**TOWN OF NEWBURGH  
PLANNING BOARD  
TECHNICAL REVIEW COMMENTS**

**PROJECT NAME:** HILLSIDE LAND DEVELOPMENT  
**PROJECT NO.:** 22-27  
**PROJECT LOCATION:** SECTION 34, BLOCK 2, LOT 66/24 JEANNE DRIVE  
**REVIEW DATE:** 28 APRIL 2023  
**MEETING DATE:** 4 MAY 2023  
**PROJECT REPRESENTATIVE:** FELLENER ENGINEERING, LLP

**2 DETENTION POND OUTLET STRUCTURE**  
N.T.S.

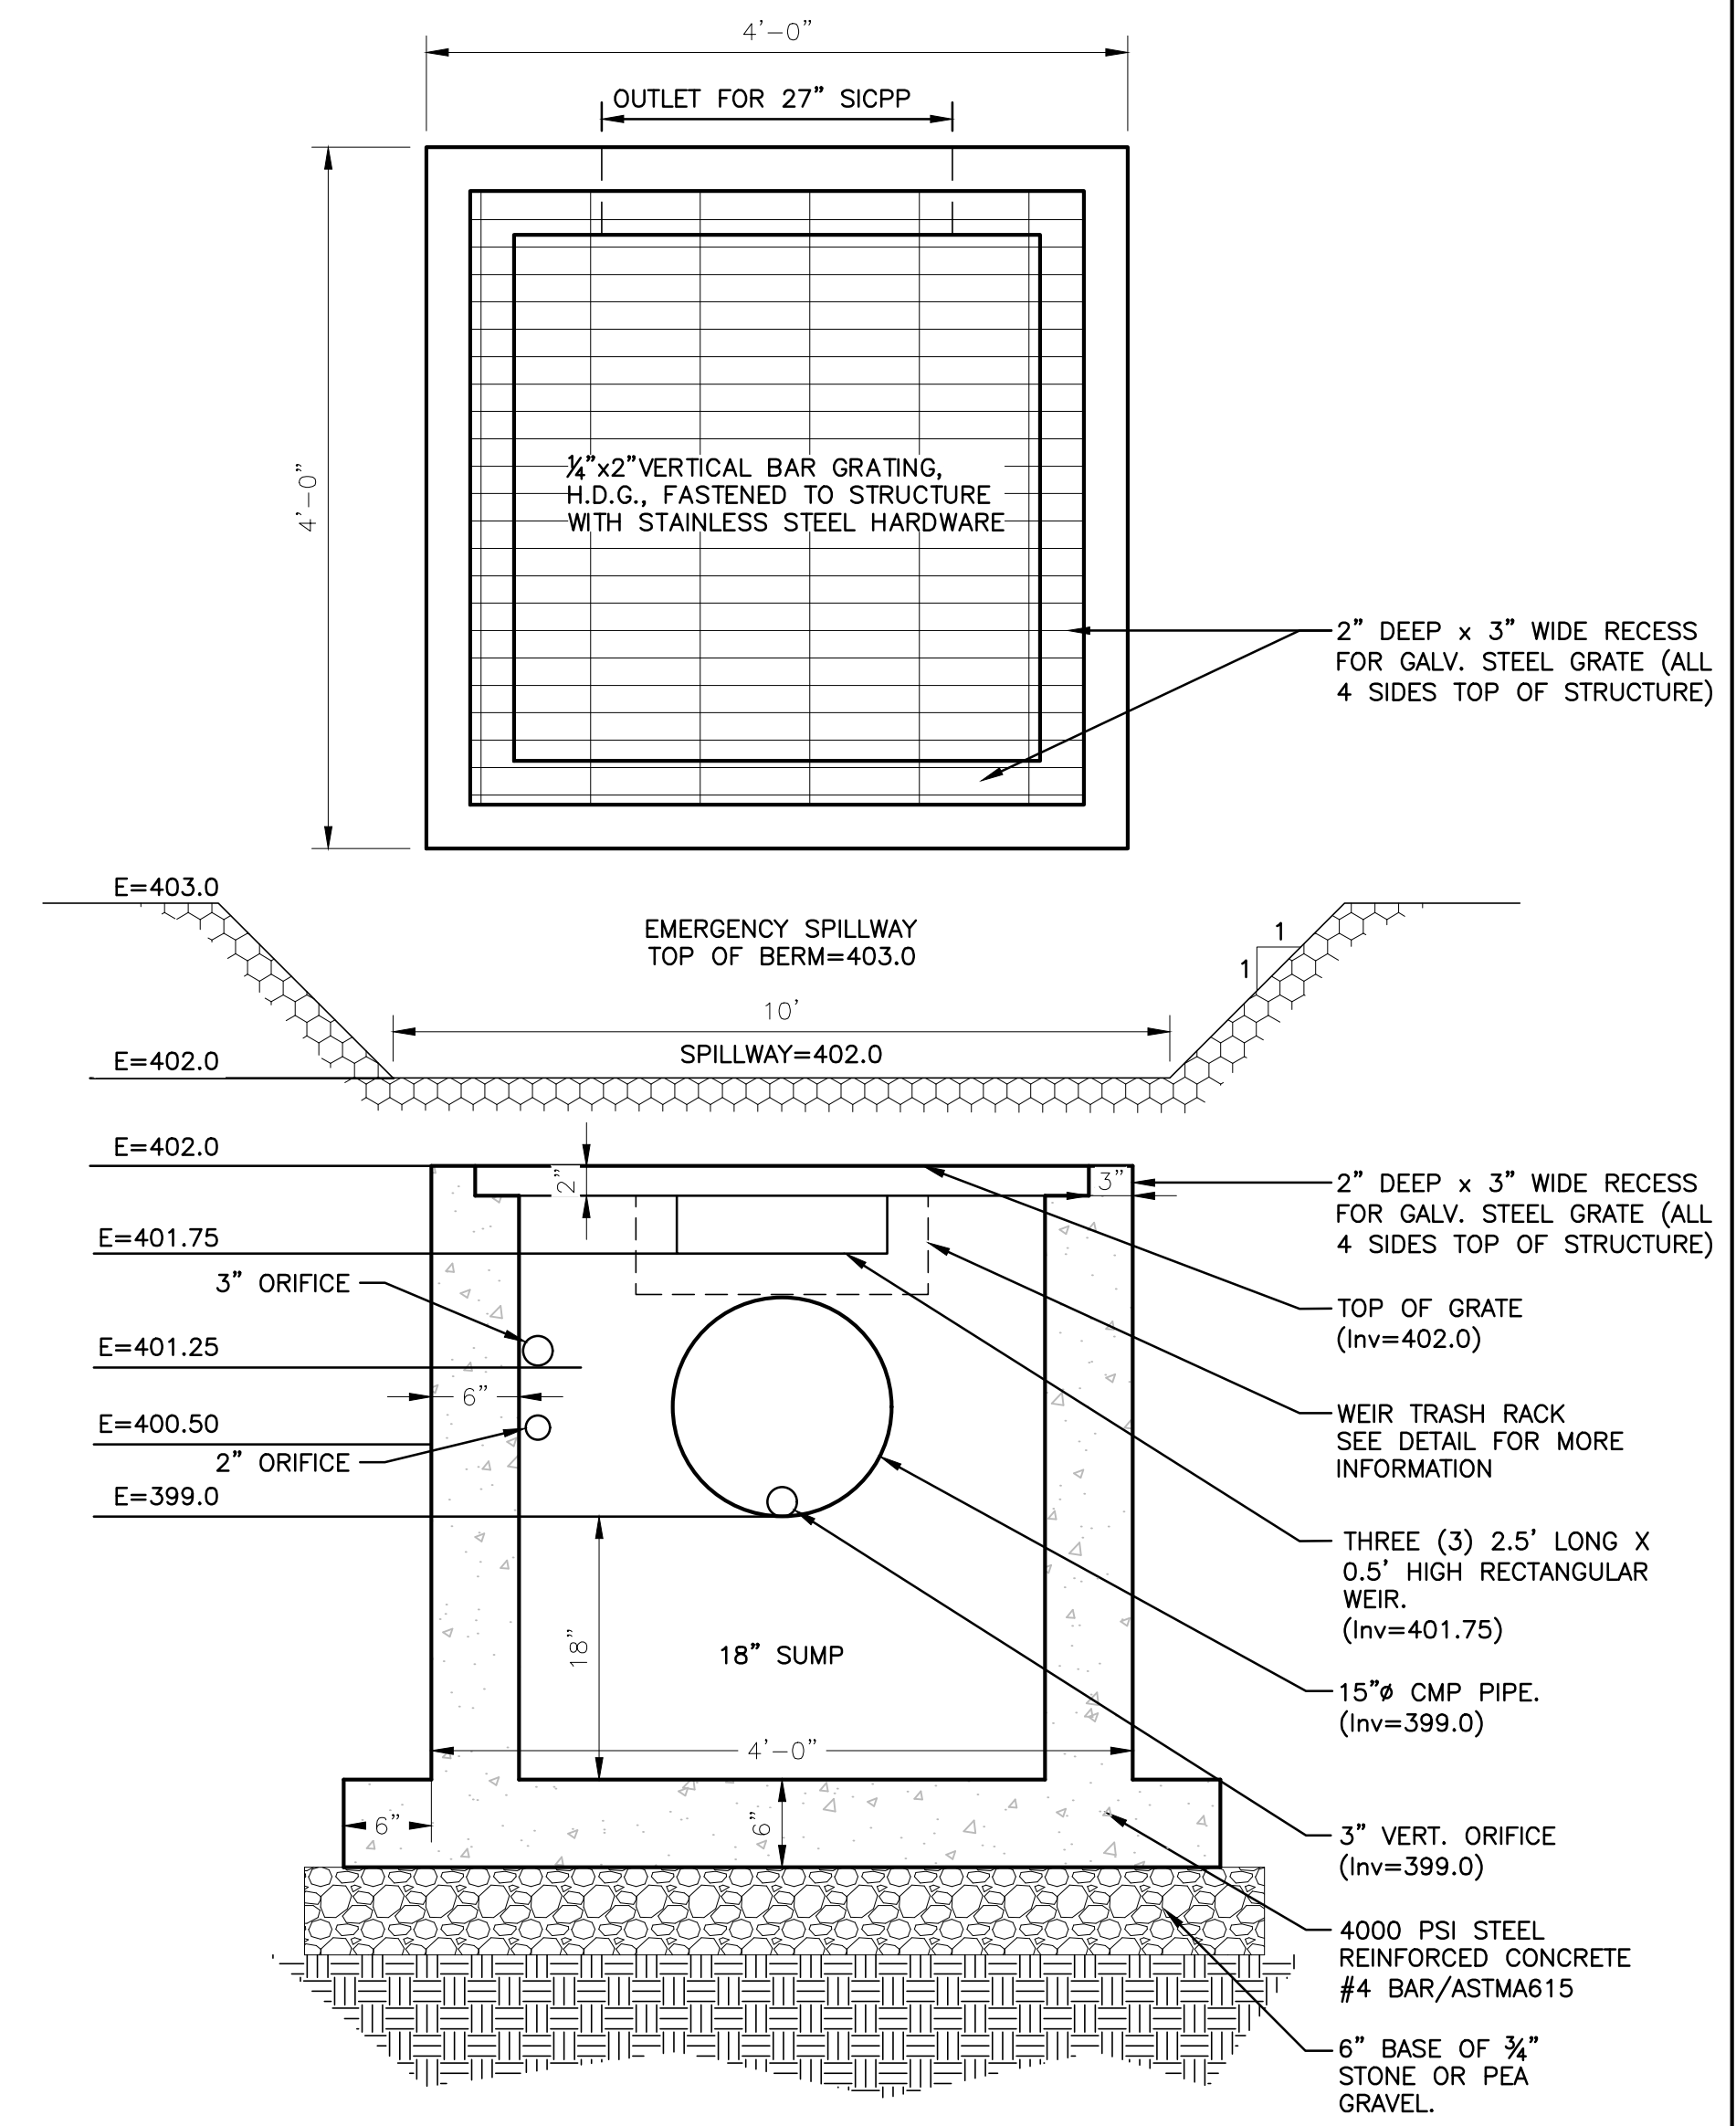
3. Similar comments for the retention pond outlet structure detail identifies the invert for the 15 inch discharge pipe at 399.0, while the model identifies it at 399.83. The first 3 inch vertical orifice is identified at elevation 399.0 while it is not included in the model.

**4 CULTEC CHAMBER OUTLET STRUCTURE**  
N.T.S.

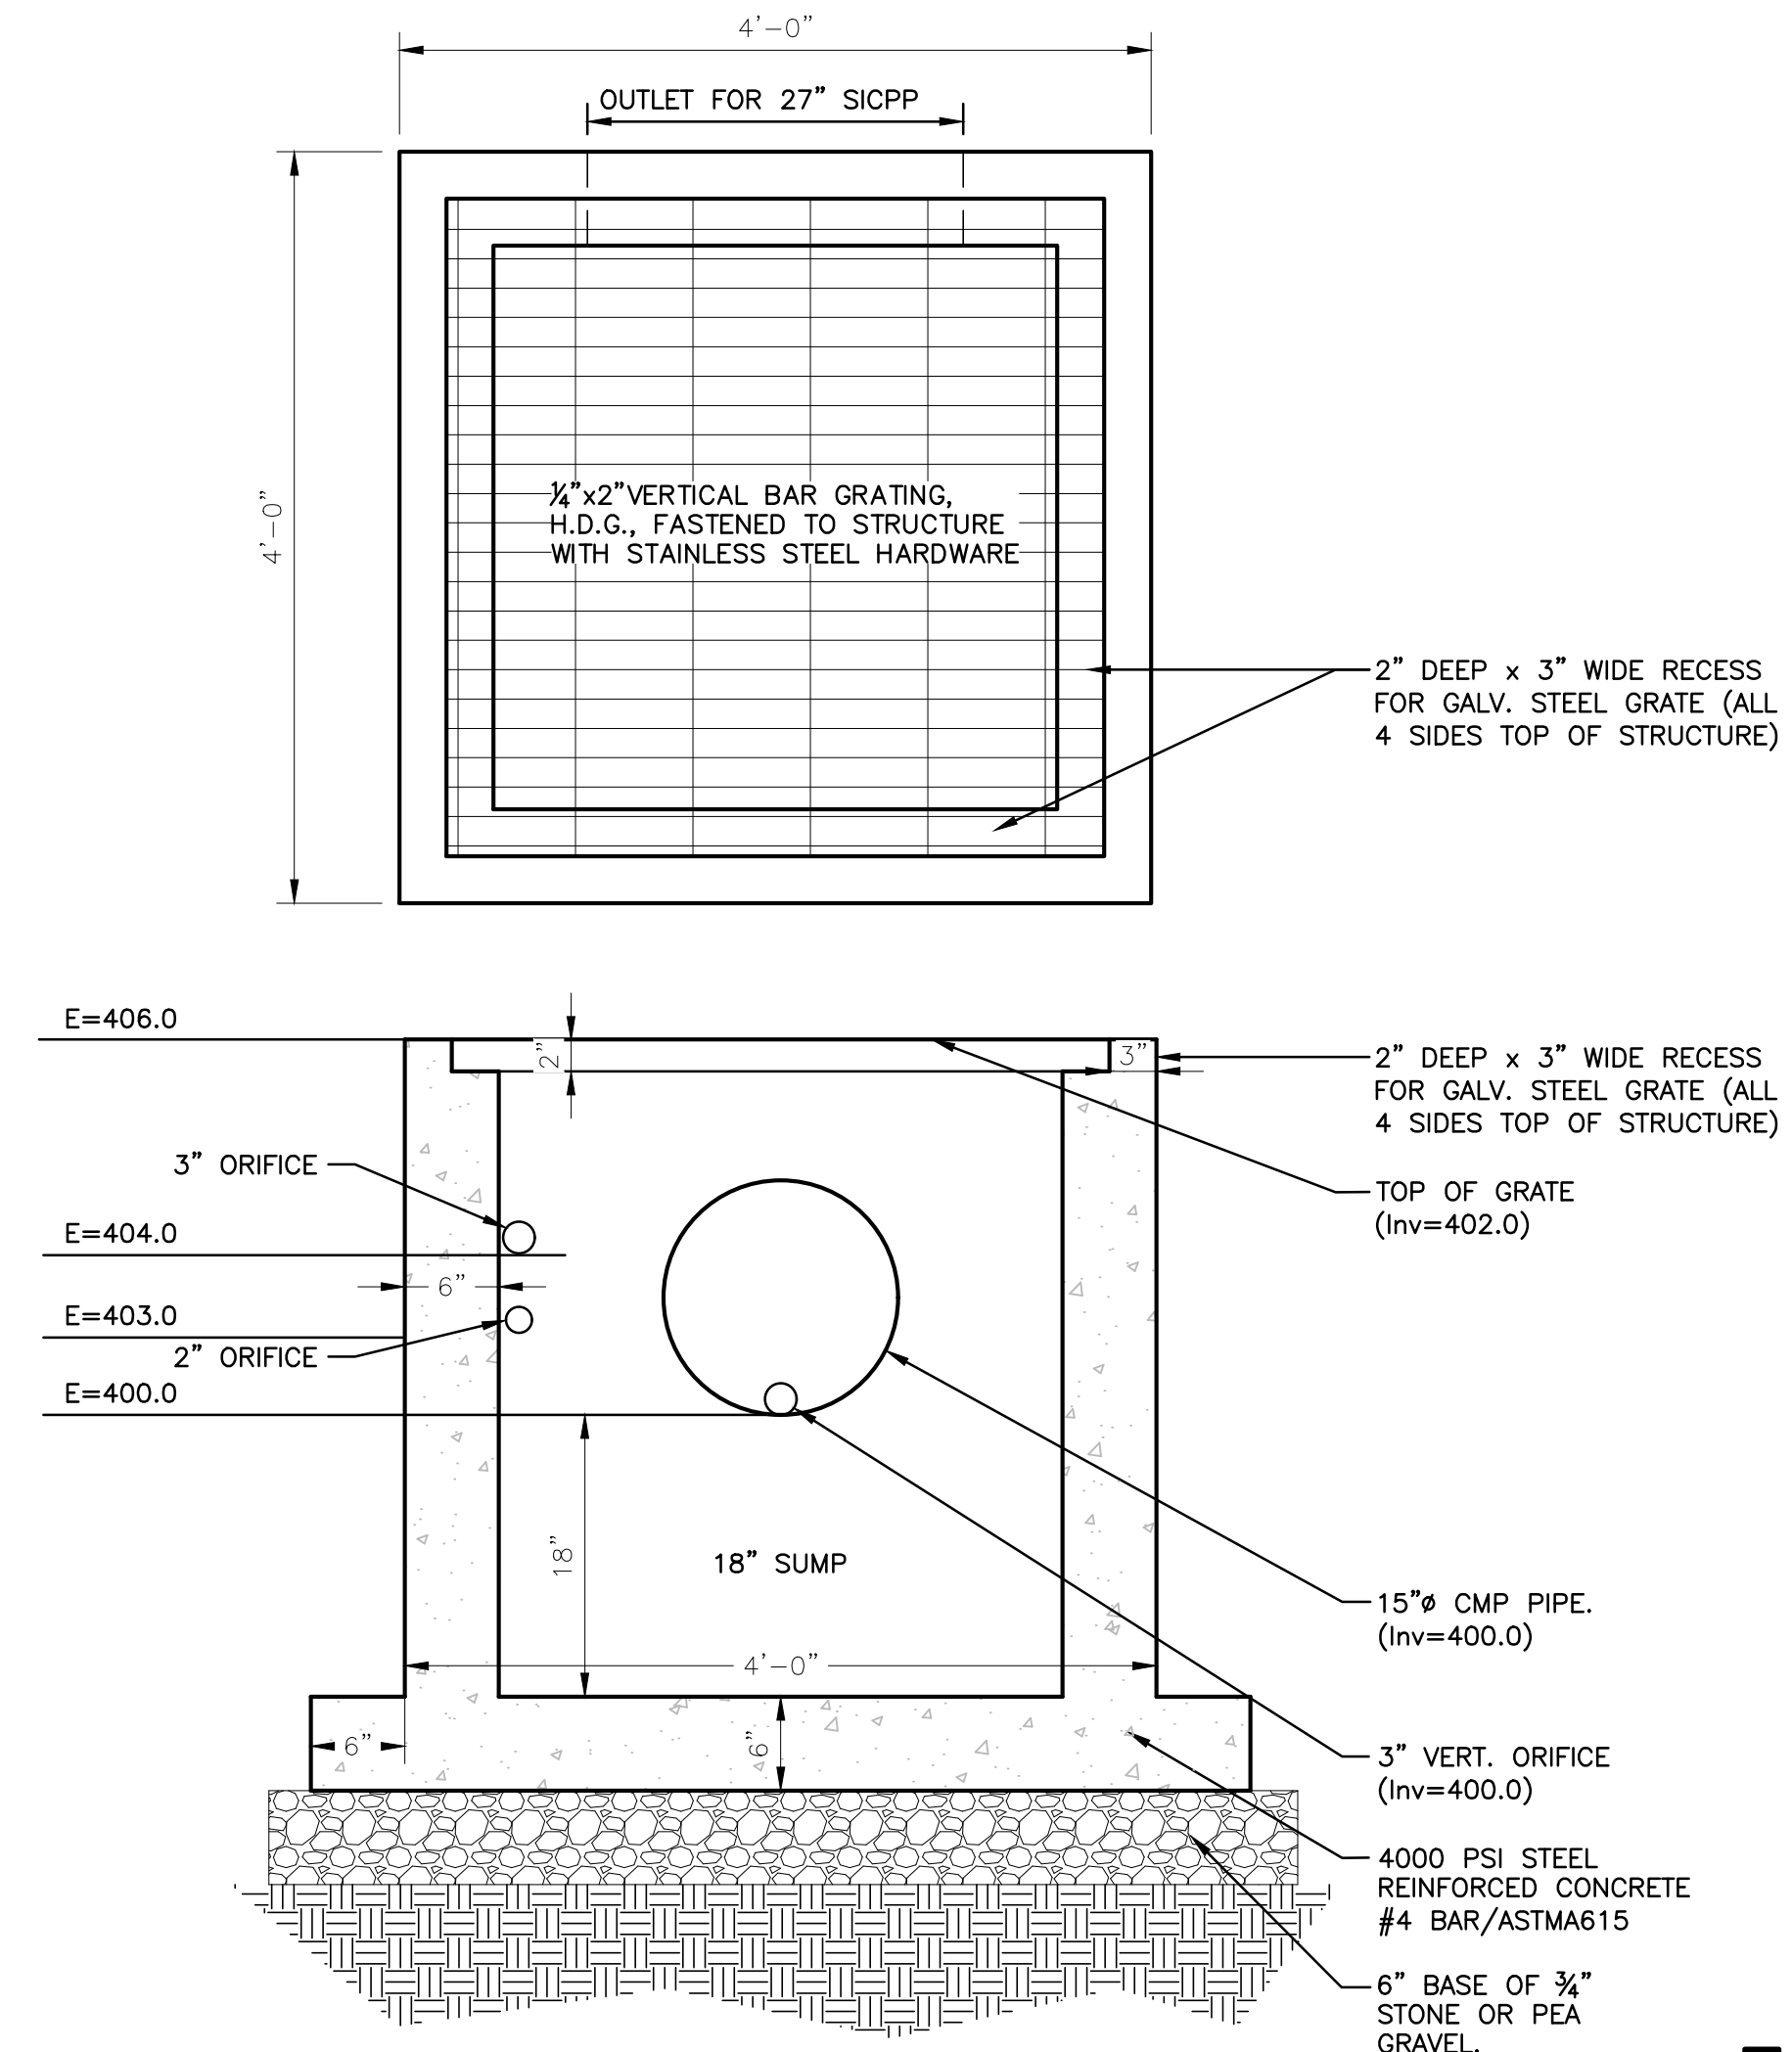
1. The applicant's representative are requested to coordinate the Cultech Chamber outlet structure with the inverts and discharges within the Stormwater Management Report. Primary invert for the Cultech Chamber is identified at 401.83, the plans identify it at 400.

2. A 3 inch vertical invert at elevation 400 is depicted on the plans, however not modeled in the control structure. It is unclear from a review of the plans where the influent to the Cultech system is.
